# Mount Street 100 North Sydney

Preferred Project Report

December 2009

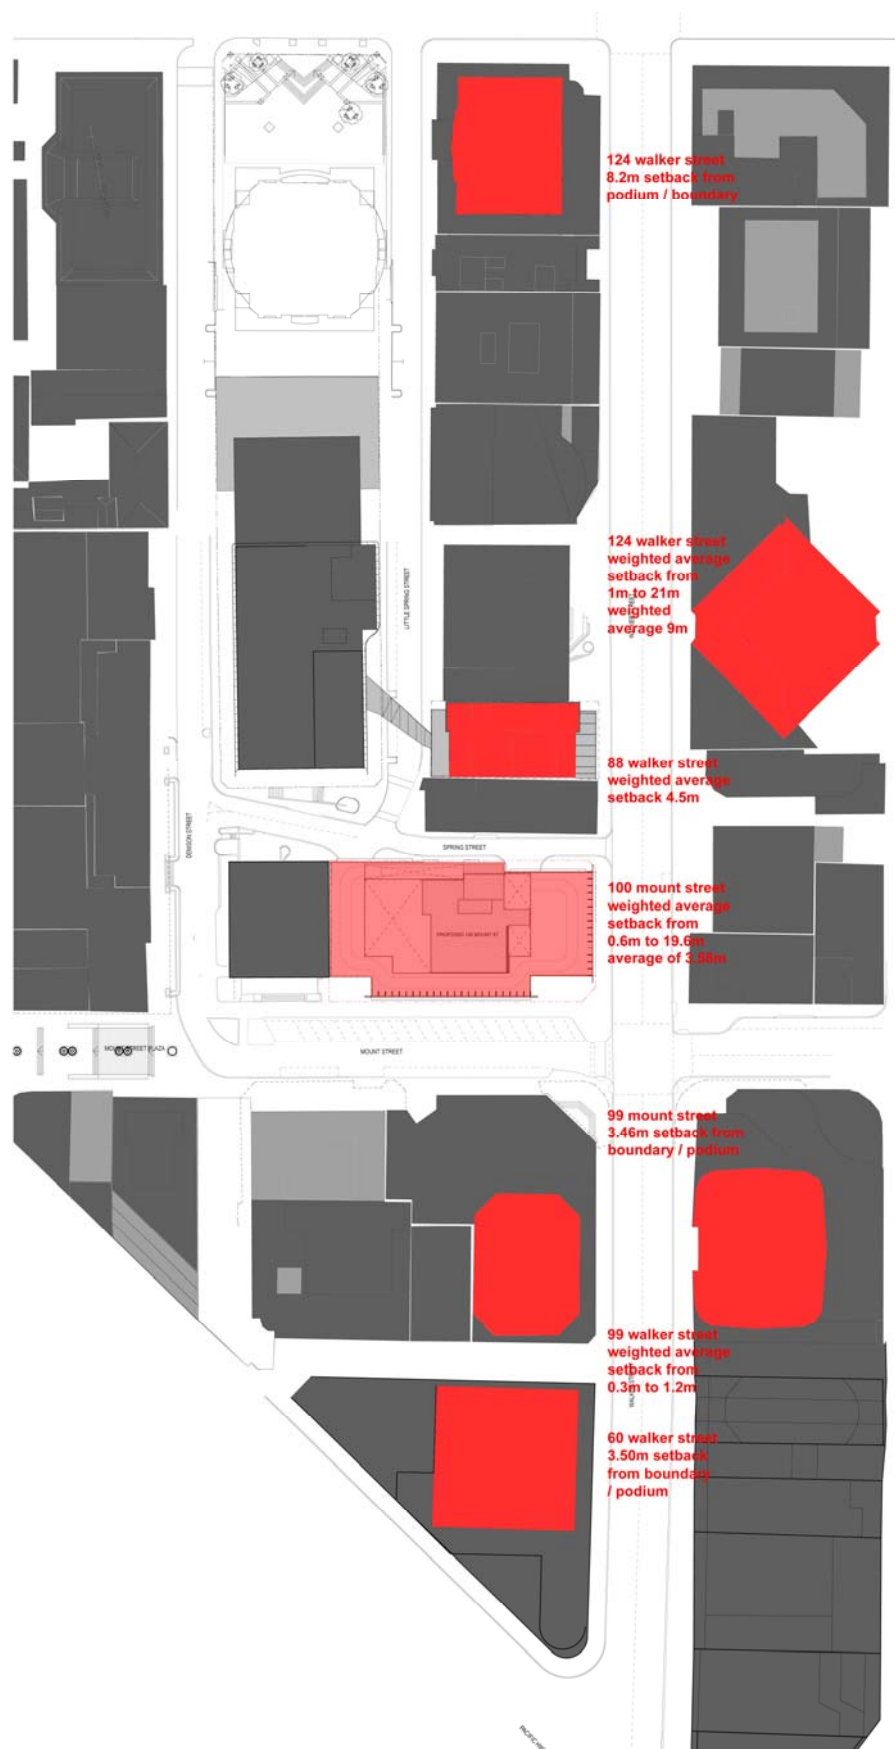
The purpose of proposed projection forward at the upper levels is:

- To achieve a desired minimum floor plate of greater than 1,200m<sup>2</sup>. A large floor plate is considered necessary to ensure the building is attractive to premium commercial tenants.
- To assist in the architectural language of the building. As outlined in the attached architectural design statement, the projection forward at the upper levels is an integral part of the design intent. The intent being to present a bold and unconventional statement that befits its central CBD location and challenges the observer.

In terms of impact of the upper level projection, when considered in context with the entire Walker Street façade, which includes a variety of setbacks, the projection is considered balanced. It is noted that the streetscape along Walker Street includes a variety of tower setbacks which range between nil to 5m. With setbacks ranging from 19.6m at the lower levels and 2.1m at upper levels, the Walker Street presentation ensures that the bulk of the building is removed from the street level experience.
